Intel Technical Advisory

TA-0940-1

Intel® Server Chassis SC5650BRP with the Intel® Server Board S5500BC may fail to power on when the AUX power cable is plugged into the server board.

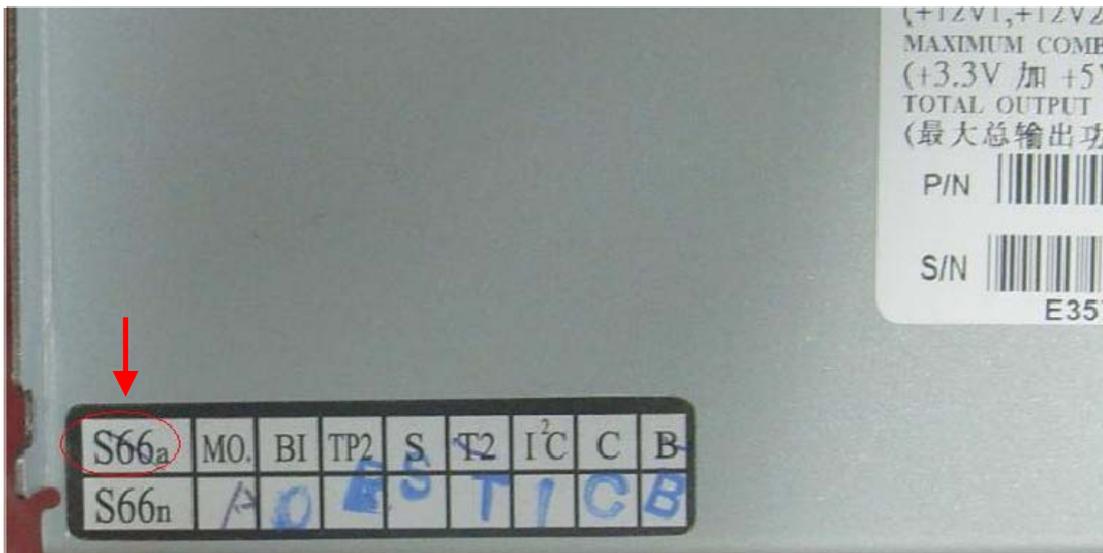
- Reworked all inventory in the Intel factories
- Reworked Knock-Down Kit (KDK) chassis can be identified by two green dots (one on the back of the case and the other on the carton sticker). See picture below:

- Reworked redundant power cages can be identified by a black line through the “S66a” box located at the bottom left corner. See picture below:
